SUBJECT: Withdraw of the November 16, 2015 Application for Modification, AND Application for Modification with Additional Information for Section 404 Individual Permit and Section 401 Individual Water Quality Certification for the US-74 Monroe Connector/Bypass in Union and Mecklenburg Counties. STIP R-3329 and STIP R-2559, Division 10, Debit WBS Element 34533.1.TA1 in the amount of \$570.

Reference: US Army Corps of Engineers (USACE) 404 Permit issued May 8, 2015; Action ID: SAW-2009-00876
NC Division of Water Resources (NCDWR) 401 Water Quality Certification Permit issued March 6, 2015; NCDWR Project No. 02-0672 V3

The North Carolina Department of Transportation (NCDOT) is in the process of constructing the Monroe Connector/Bypass, as authorized by the USACE and NCDWR as referenced above. NCDOT is requesting a permit modification for ten Permit Sites: 3, 5, 29, 30, 37, 46, 47, 48, 54, and 57, which are detailed below. Two other sites, 6 and 60, have revisions in jurisdictional areas that do not require a permit modification (see below).

Permit Site 37 (Revised Permit Drawings 147, 148, 152, and 153 of 267):

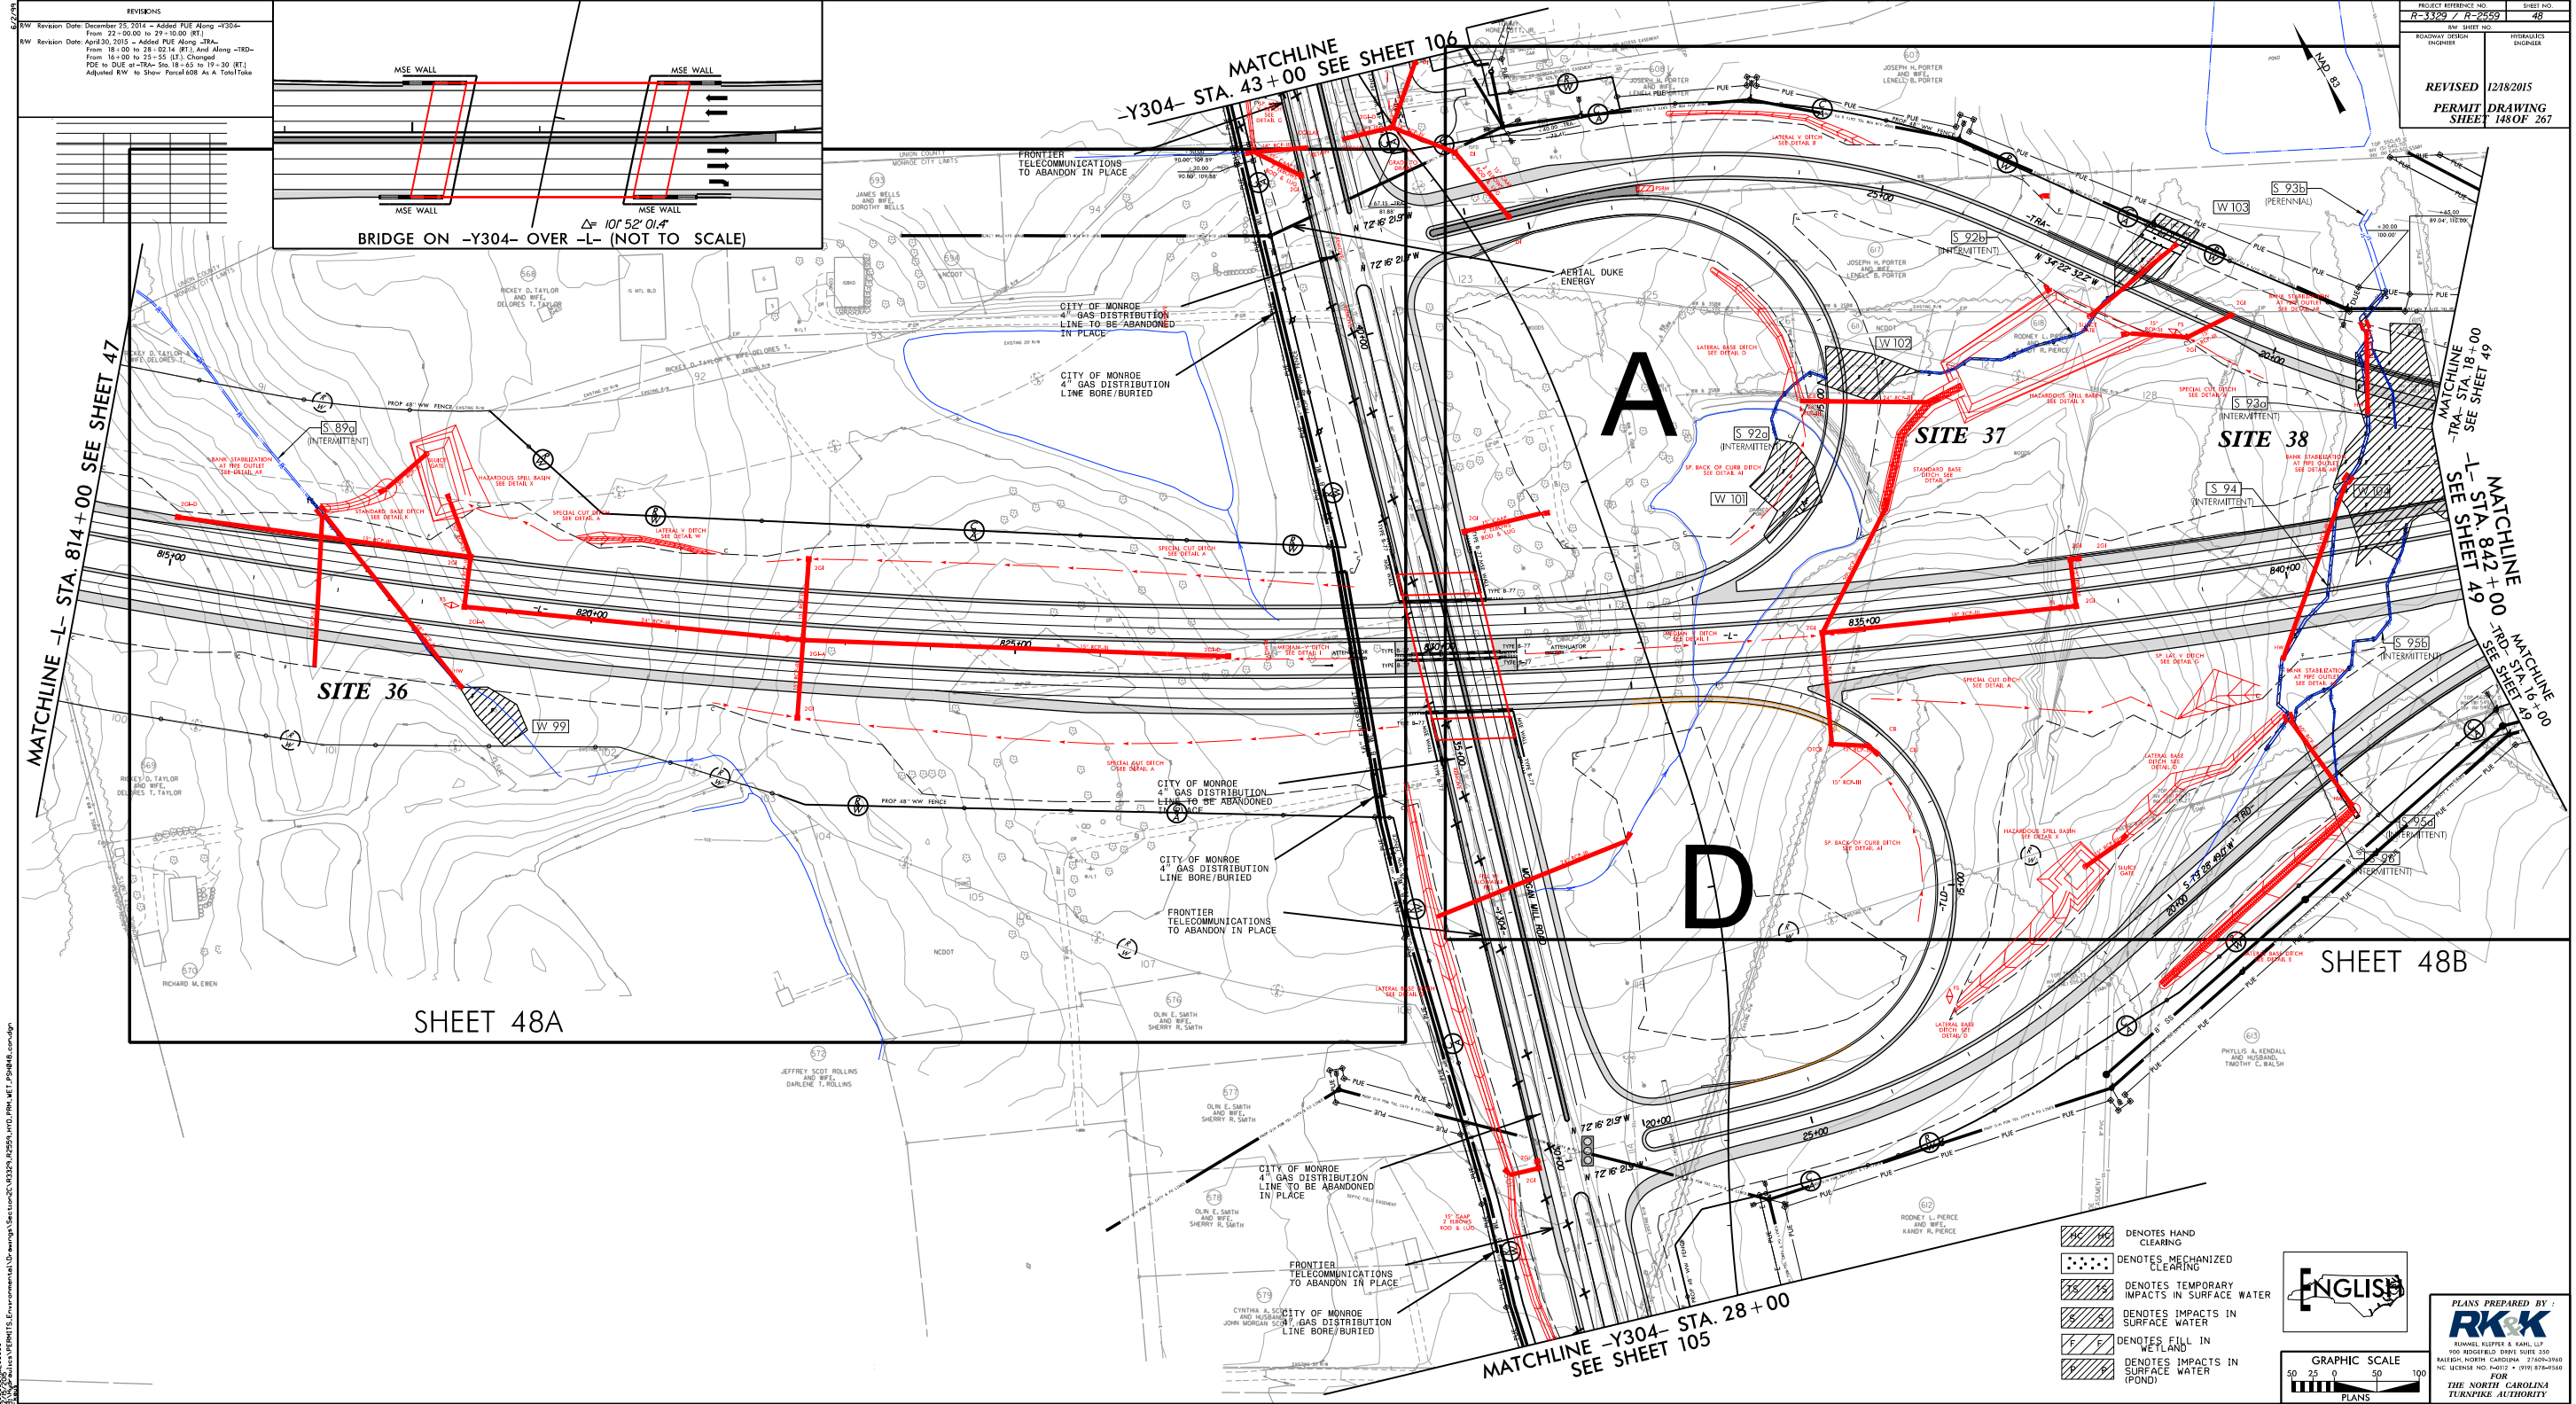
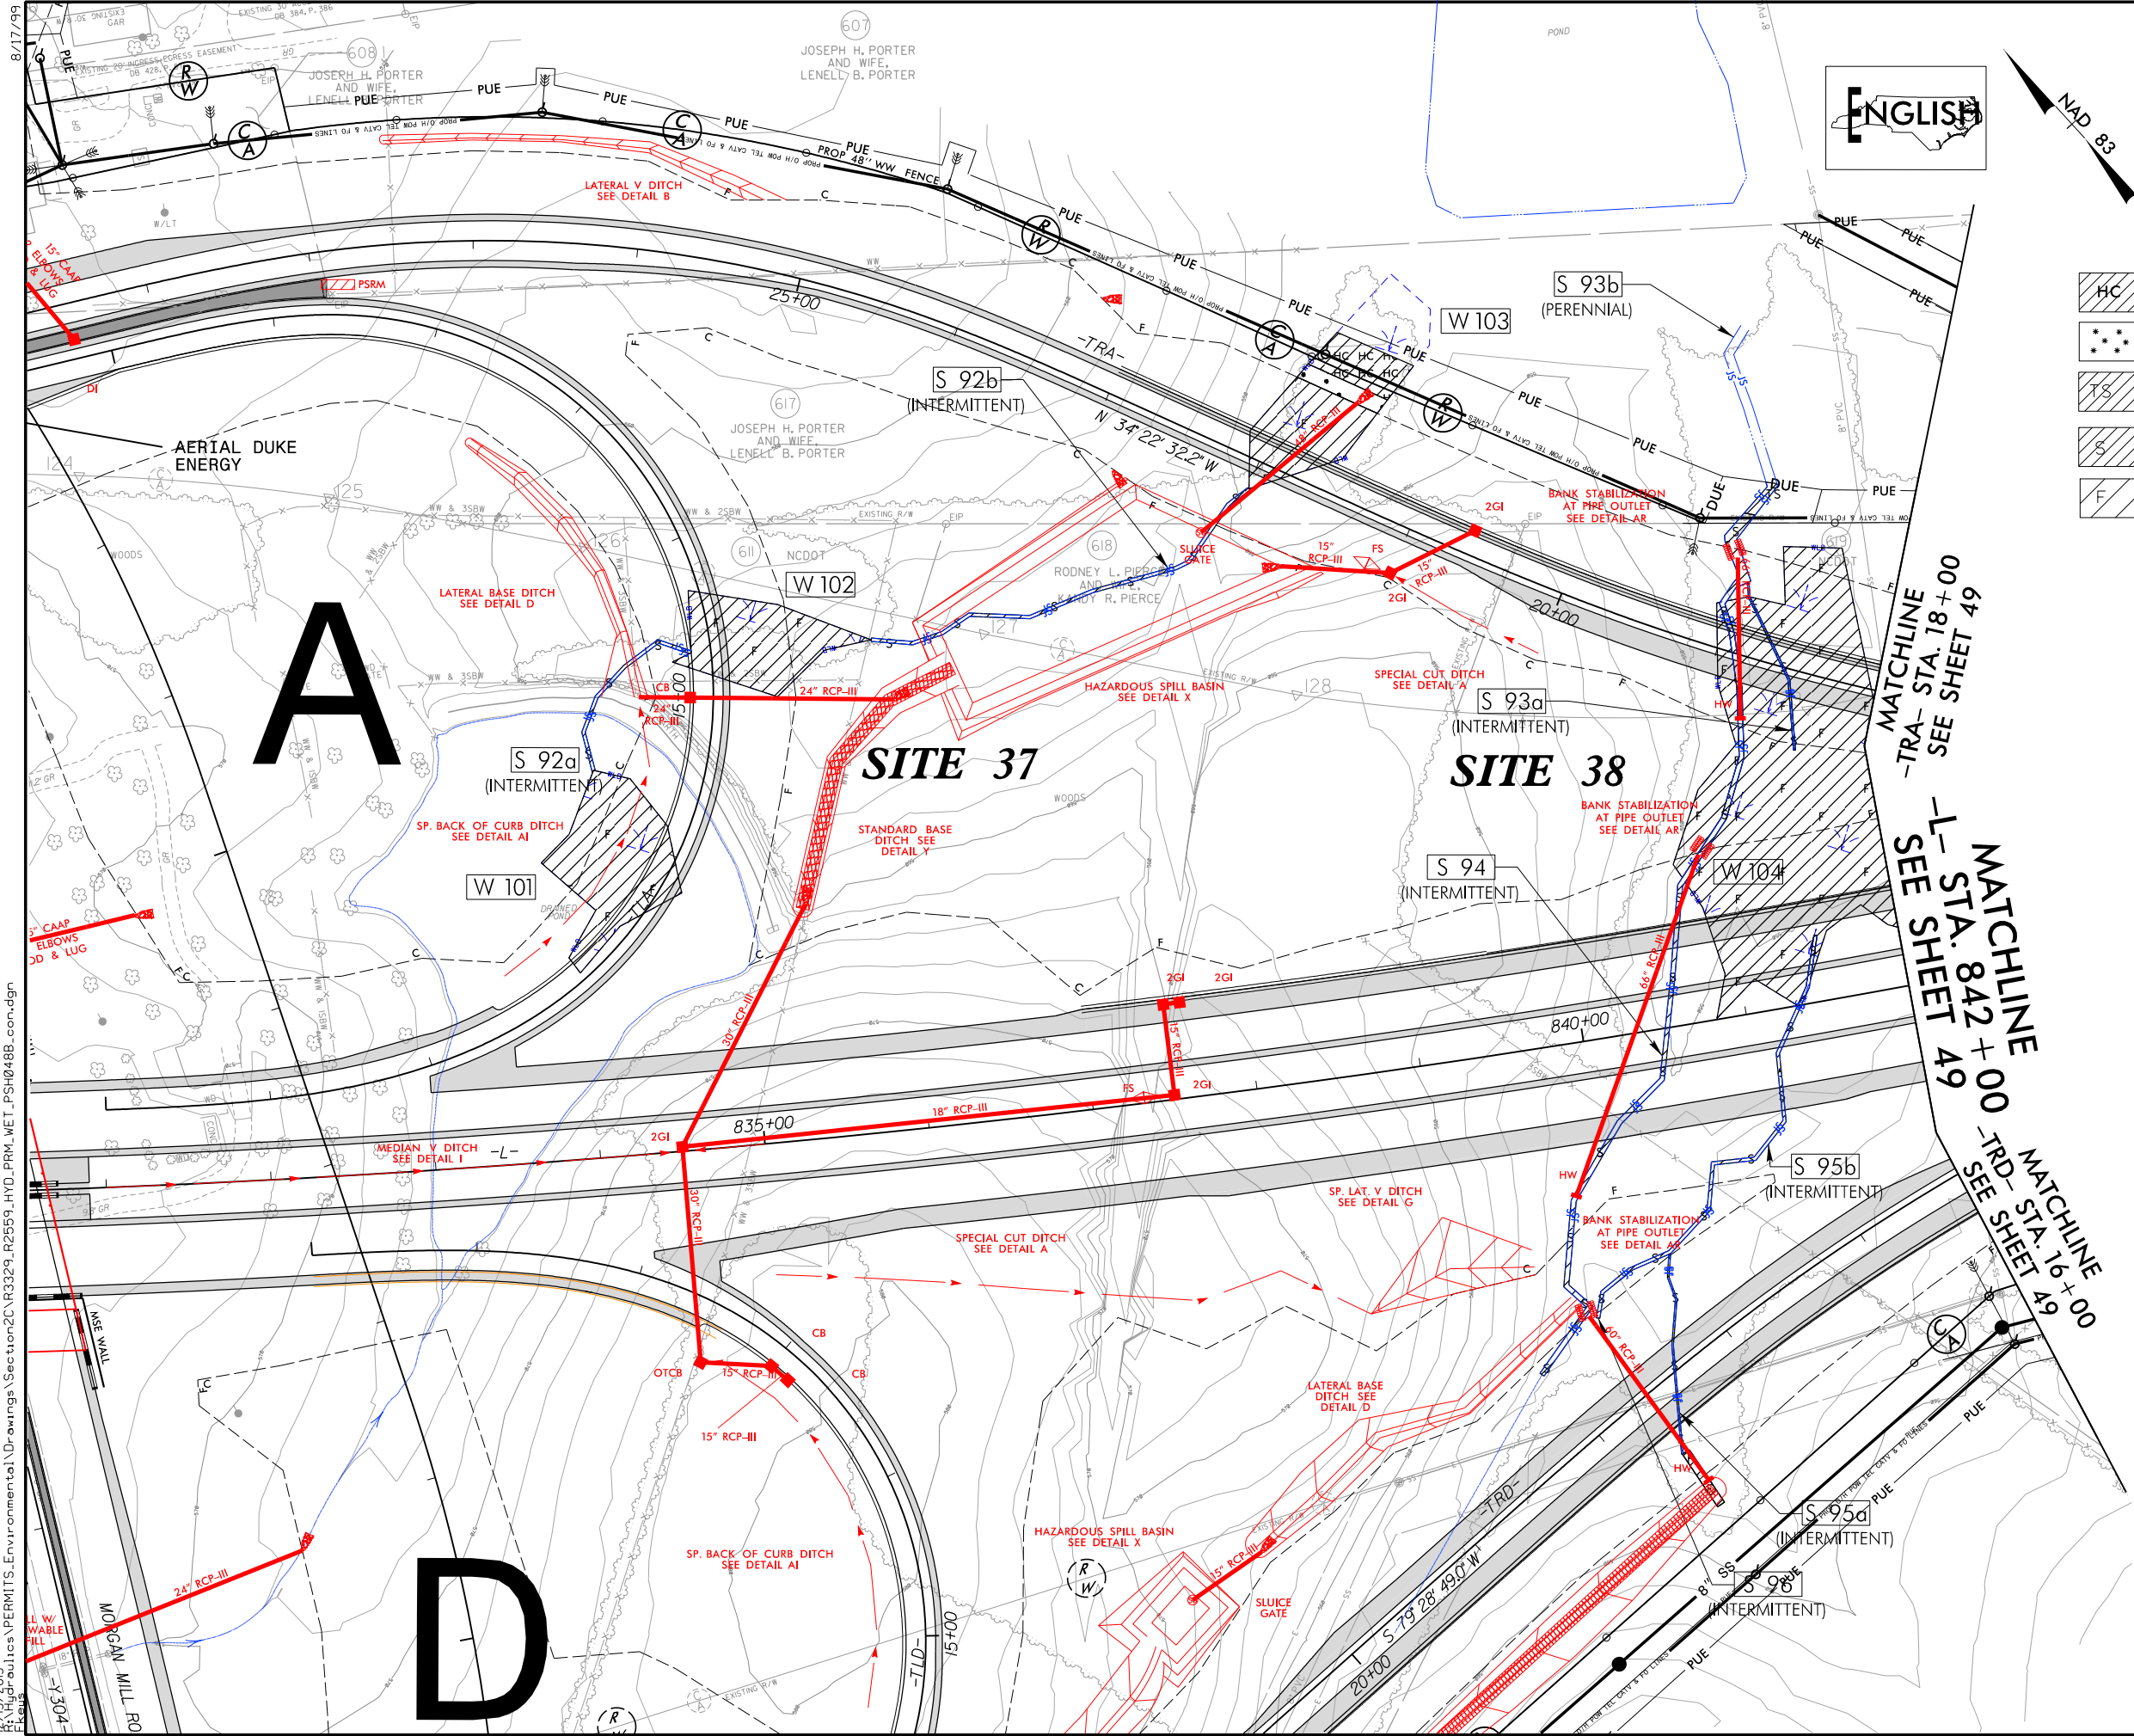
In addition to the previously permitted 0.28 acre of permanent wetland impacts, and 0.01 acre of mechanized clearing, an **additional 0.03 acre of wetland W103 will be hand cleared** in order to install overhead power, telephone, cable, and fiber optic lines.
